## HISTORIC AND DESIGN REVIEW

COMMISSION August 19, 2015

**HDRC CASE NO:** 2015-301  
**ADDRESS:** 303 W ROSEWOOD AVE  
**LEGAL DESCRIPTION:** NCB 6532 BLK 12 LOT 20 THRU 22 & E 9 IN OF 19  
**ZONING:** R5 H  
**CITY COUNCIL DIST.:** 1  
**DISTRICT:** Monte Vista Historic District  
**APPLICANT:** James Stewart/Hays Co. Organic  
**OWNER:** Jeff Turpin  
**TYPE OF WORK:** Retaining wall  
**REQUEST:**

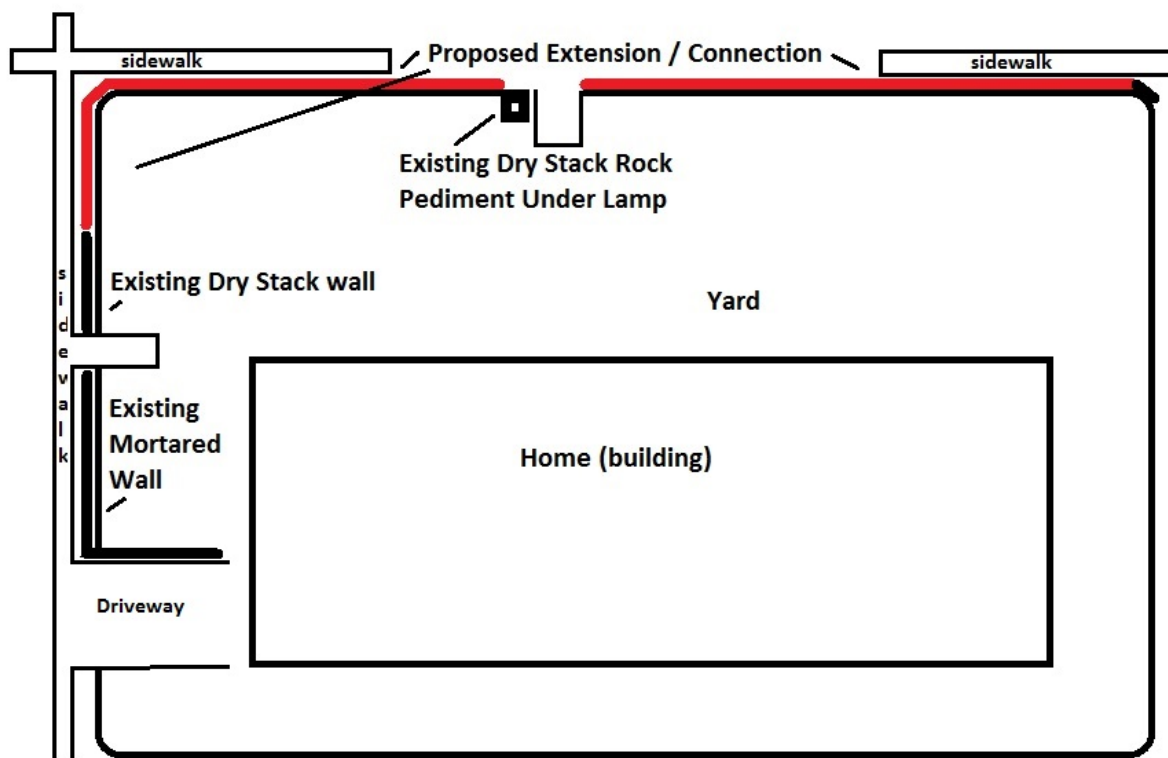
- c. According to the Guidelines for Site Elements 5.A.iii., introduction of new elements should have minimal impact on the topography and when possible should work with, rather than change, the character defining topography. The applicant has proposed to backfill space behind retaining wall to create a flat lawn. This is not consistent with the Guidelines.

- d. The property has an existing 30’ in length dry stacked limestone retaining wall located along the property’s west side facing Belknap Street. The applicant proposes to connect the existing dry stacked limestone wall with a new 15” high by 12” wide “faux dry stack” limestone retaining wall. The proposed retaining wall will extend along Belknap Street and along Rosewood Avenue. According to Guideline 5.B.ii. on Location, fence or walls should avoid installation in a location where one did not historically exist, particularly in the front yard. This is not consistent with the Guidelines.
